# PL201800160

**Wendy's**  
9624 LYNDALE AVE. S.  
BLOOMINGTON, MN 55420

SHEET NAME  
EXTERIOR ELEVATIONS

# A2.1

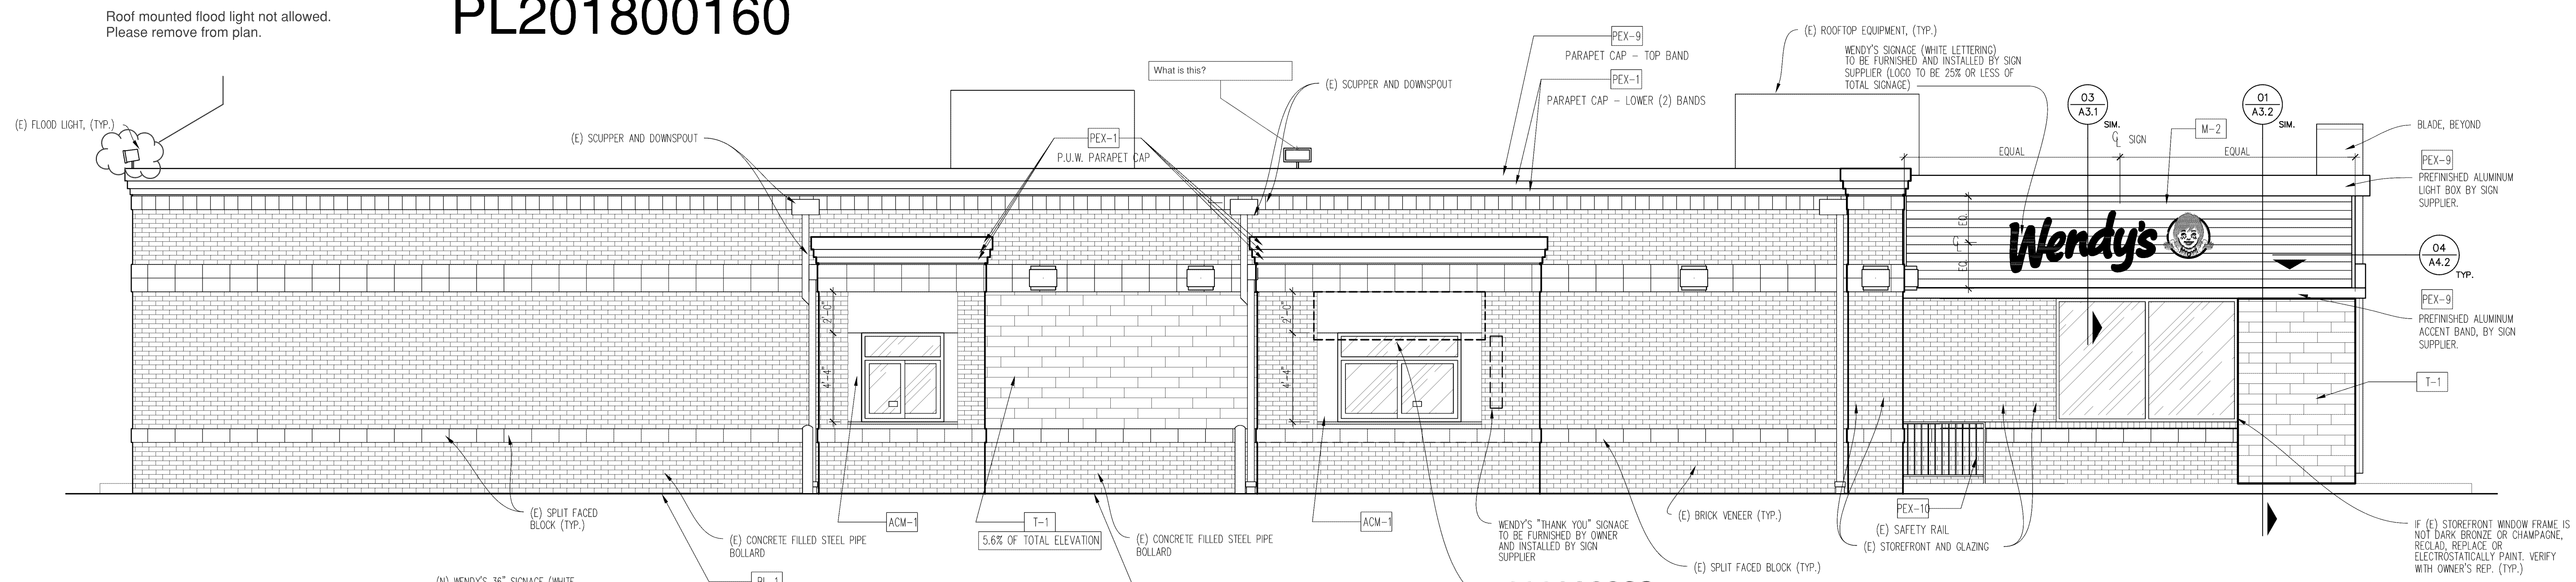
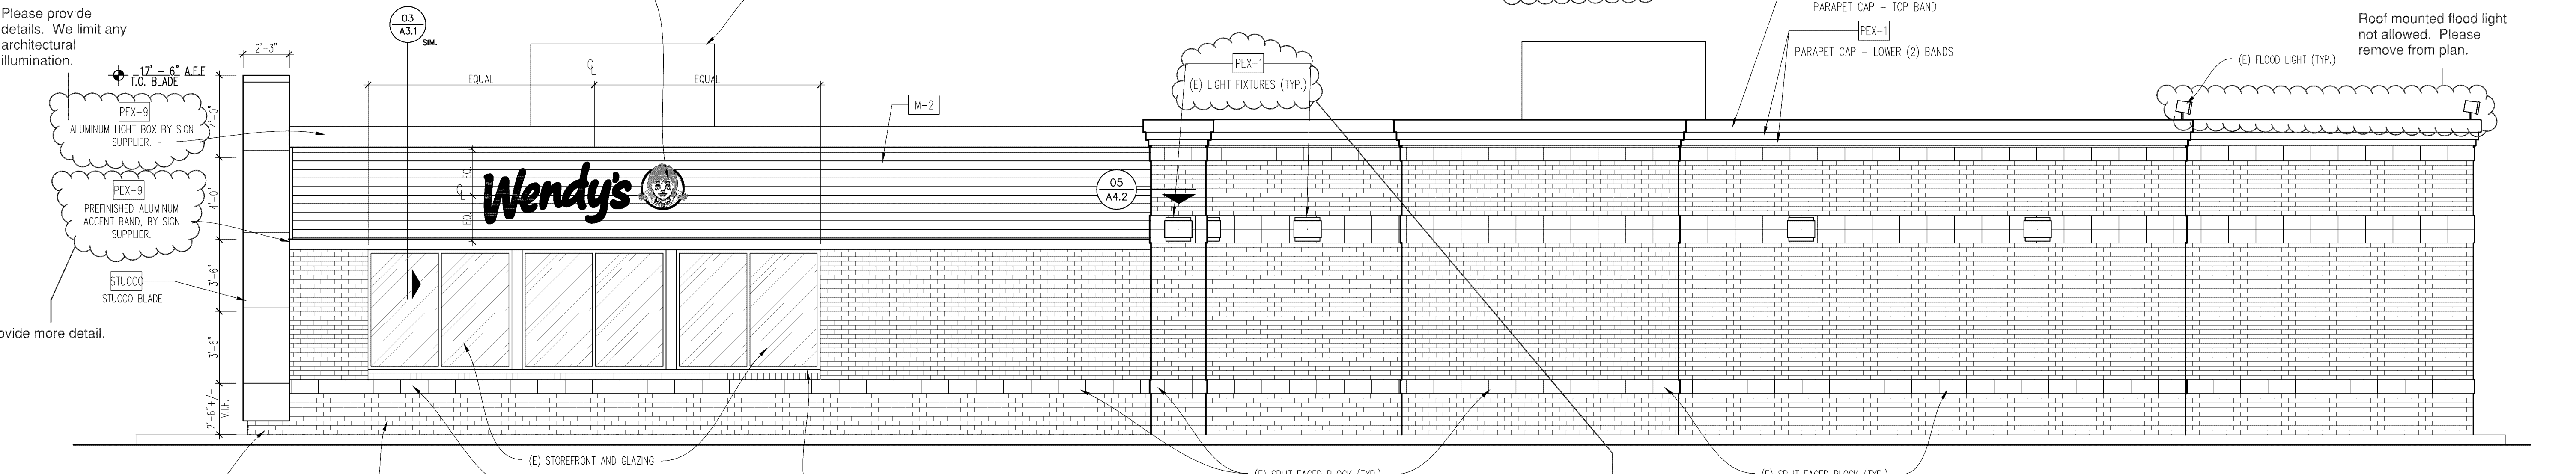
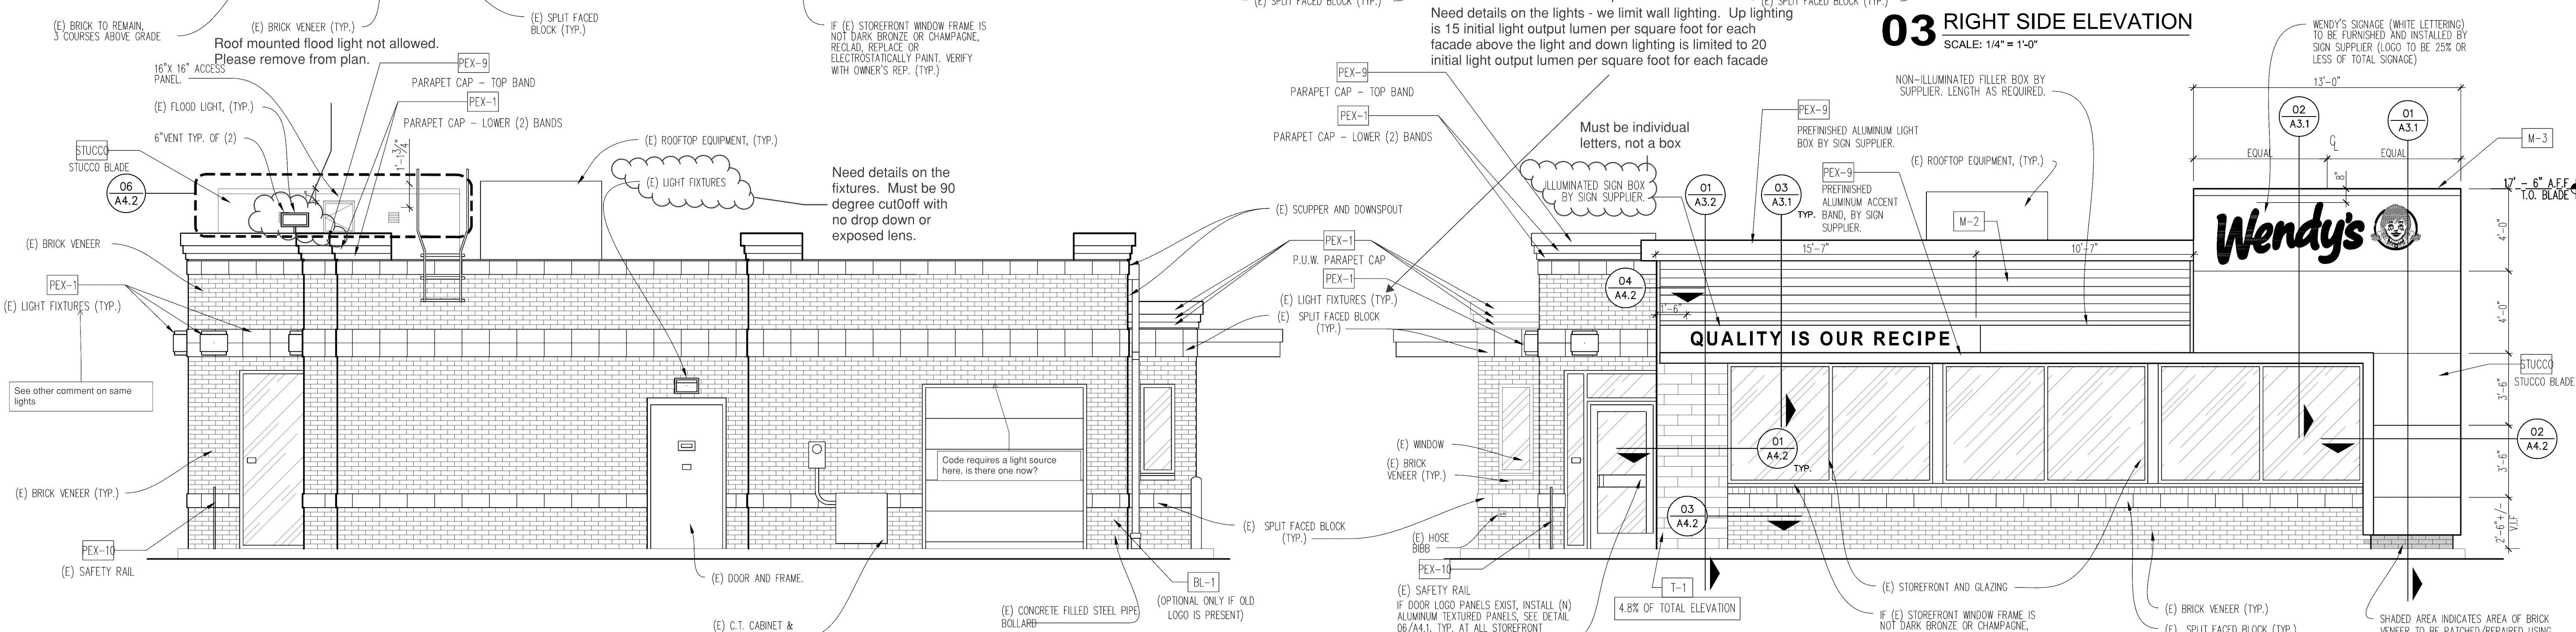
I've attached the exterior elevation sheet and marked up some of your comments, and also attached wall section and detail sheets for more detail on a few items. (I'm working on digging up cut sheets). Please ignore the metal panels that are shown for the exterior blade on the wall sections and details, I am in the process of changing these details to a stucco system.

1. Application fee has now been paid!
2. You noted that only 2 signs are allowed, I marked on the elevations that we will remove one from the plans.

3. The "QUALITY IS OUR RECIPE" sign will be changed to individual lettering.
4. Flood lights will be removed
5. All of the lighting on the exterior is existing, do you still need cut sheets on these? We are not intending on removing or replacing. (E) indicates and existing item.
6. I do not believe there is a light above the rear overhead door. I'll look into this and install an approved fixture if needed.

Thanks for the update, I will process as such. I have attached some comments on the plan attached and some clarifications and changes are required.

Also, I noted the wall signs on three sides? I see that is there not and did a permit history and there was never a permit for the third side. Not sure how they were placed on the building. Code allows wall signs on two walls only. In addition, the "sign" box with the "quality is our recipe" is not allowed. They can mount individual letters, assuming this is the side they chose to have signs, but the box is not allowed as you are limited to individual letters with the one logo cabinet per allowed façade. When I process for approval, I will redline and condition as such.
